**STAFF REPORT:** 10/08/2025 REGULAR MEETING      **PREPARED BY:** L. SAINT JAMES  
**APPLICATION NUMBER:** HDC2025-00461 & HDC 2025-00464  
**ADDRESS:** 2011 & 2025 ORLEANS  
**HISTORIC DISTRICT:** LAFAYETTE PARK/MIES VAN DER ROHE  
**APPLICANT:** RAYMOND SINCLAIR / THE HOME DEPOT  
**2011 ORLEANS PROPERTY OWNER:** DOUGLAS THEDFORD / TRUDY THEDFORD  
**2025 ORLEANS PROPERTY OWNER:** FRANCINE BURGESS  
**DATE OF PROVISIONALLY COMPLETE APPLICATION:** 08/25/2025  
**DATE OF STAFF SITE VISIT:** 09/24/2025

**SCOPE:** REPLACE HISTORIC ALUMINUM WINDOWS WITH FIBREX WINDOWS

*Photos from application. South elevation.*

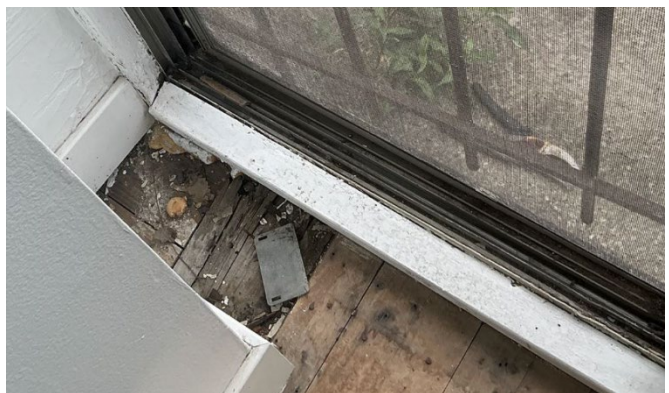
- There is a total of five (5) sections of windows between both units that are proposed to be replaced.

- The applicant states “The building currently retains its original window units, which are aluminum-framed, early-generation double-pane glass panels installed during original construction circa 1966. While these windows were once modern in appearance and functional for their time, they now exhibit signs of significant wear, energy inefficiency, and safety concerns.” They also provide the following descriptions of the existing conditions:
  - *Structural and Operational Deterioration: Many of the current windows have rusting or pitted frames, compromised locking mechanisms, and non-functional sashes, creating not only aesthetic issues but also safety and egress concerns.*
  - *Moisture Infiltration: Several units have reported water penetration at the window perimeters, creating risks of mold, interior damage, and long-term structural decay.*

- Although the existing aluminum window systems are distinctive and historic character-defining features, considering the amount deterioration, it is staff's opinion that the existing historic aluminum window systems are beyond reasonable repair.
